NUMBER
DEP16253

Addendum Number: 01

**Addendum #1 - Questions During Pre-Bid Conference
For DEP16253
Cub Branch Development
Permits S-5034-87 & U-5035-87**

BID ITEM TECHNICAL SPECIFICATIONS – REVISED

CHANNEL #1 PROFILE

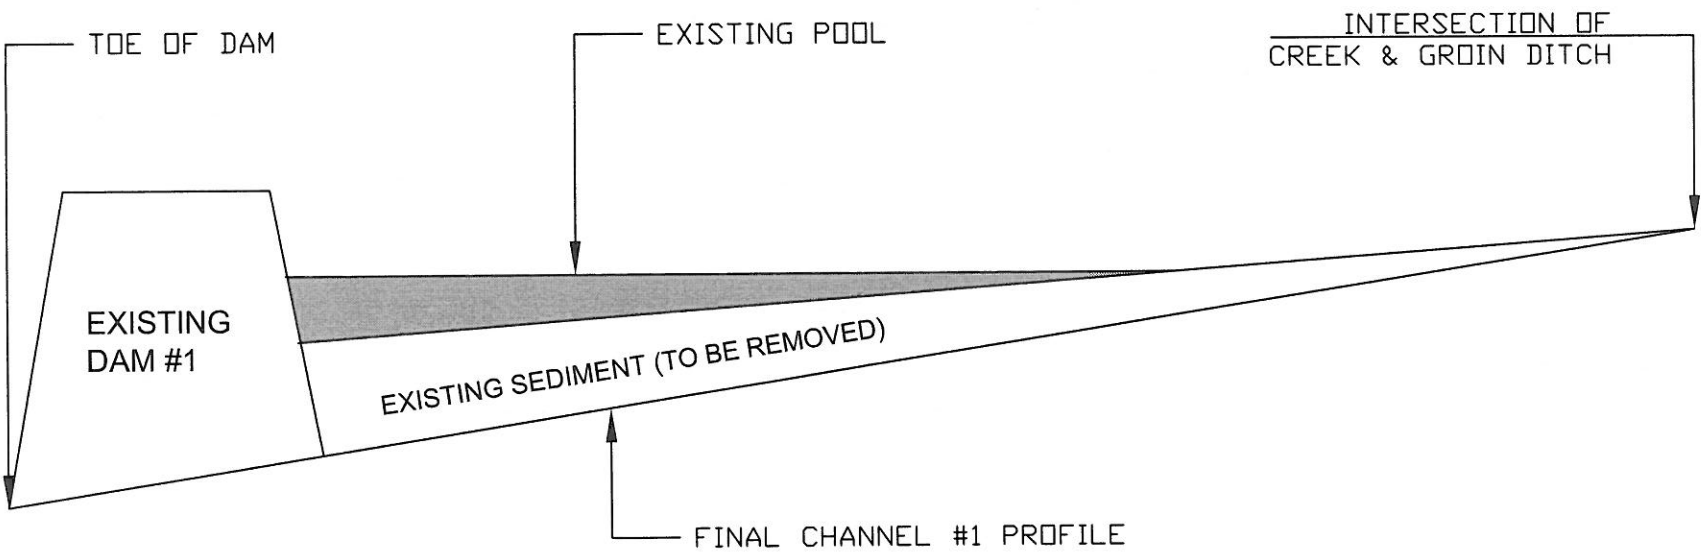
Clarification: See response to Question #3 and attached new drawing for a profile of the Pond #1 area, including final ditch #1 profile.

*NOTE: FINAL CHANNEL SHALL BE CONSTRUCTED IN STABLE, SOLID MATERIAL, AS APPROVED BY ON-SITE DEP REPRESENTATIVE

TYPICAL SECTION

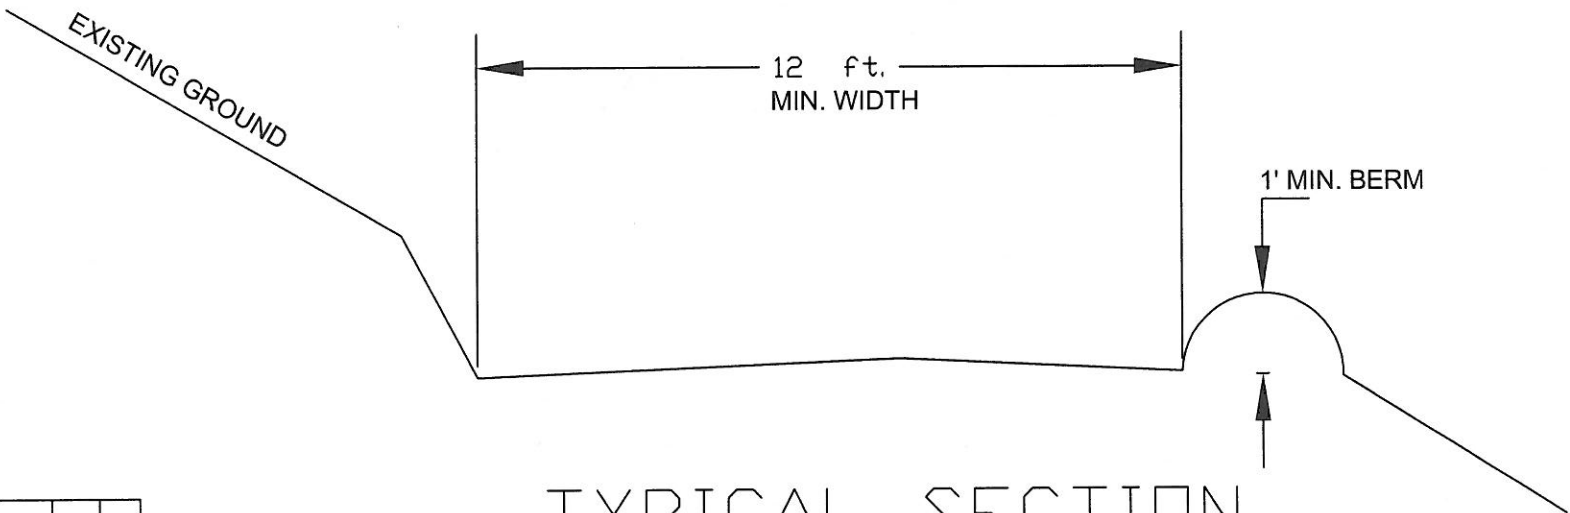
Clarification: Access roads will be constructed for both Pond #1 and Pond #2A per the attached new typical road section drawing. All material from road cuts / upgrading will be transported to a stable area (per prior approval of on-site DEP representative). Material may also be used for road abandonment or pond reclamation with prior approval of on-site DEP representative.

NOTE: THE EXISTING ROAD SHALL BE REGRADED AND SHAPED AS NECESSARY TO MEET THESE SPECIFICATIONS.
